**PR/0838/22**

## Record of Executive Business and Chief Executive's Order

**Reg. Reference:** SD22A/0030      **Application Date:** 08-Feb-2022  
**Submission Type:** Additional      **Registration Date:** 08-Jun-2022  
Information

**Proposed Development:** (1) Rear extension consisting of a store on the ground  
floor, a surgery and autoclave room on the first floor;  
(2) replacement of existing (old) roof slate tiles with  
matching new slate tiles of a semi-detached  
'Protected Structure'.

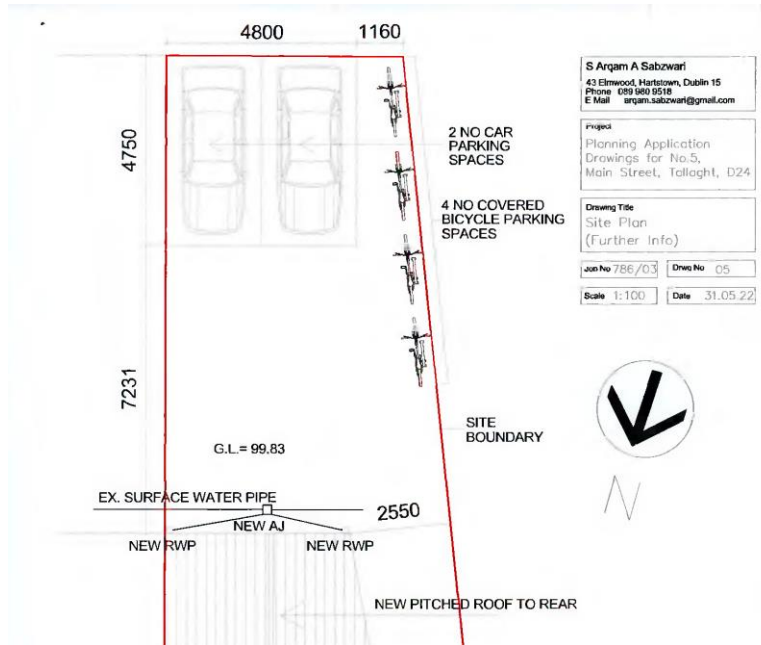
*The applicant has submitted a drawing showing a revised parking layout with provision for 4 no. secure and covered bicycling parking spaces. This is considered acceptable by the Roads Department.*

- 1. Covered bicycle parking spaces shall be constructed in line with National Cycle Manual standards.*
